REMARKS

APPLN. NO. 09/852,445

ATTY. DKT.: TOPP-P2-US

FIG. 7

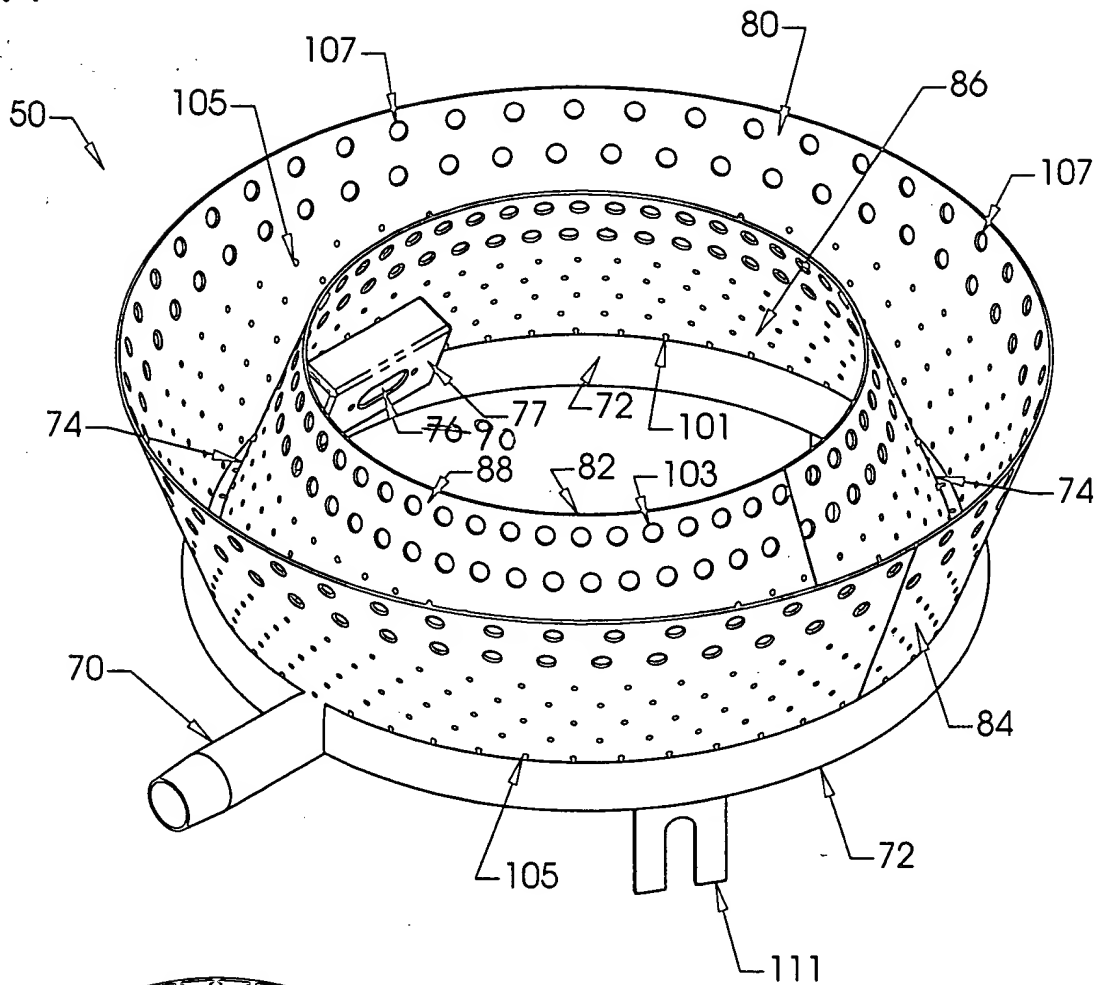
The Examiner noted that reference numerals 76 and 90 were both used to identify the ignitor. Applicant has deleted reference numeral 76 on Figure 7 and renumbered it 90. Applicant submits herewith a copy of Figure 7, with the change in reference numeral marked in red, and requests the Examiner's authorization to permanently amend Figure 7 accordingly.

Gas enters the combustion system 50 through tube 70 and eventually is relatively evenly distributed throughout ring-shaped burner tube 72. As gas leaves via gas exit holes 74 it is ignited by ignitor 90 [76]. After the gas is ignited, the control circuit ensures that a stream of gas exits gas holes 74, thereby ensuring that a flame is continuously lit at the combustion system 50.
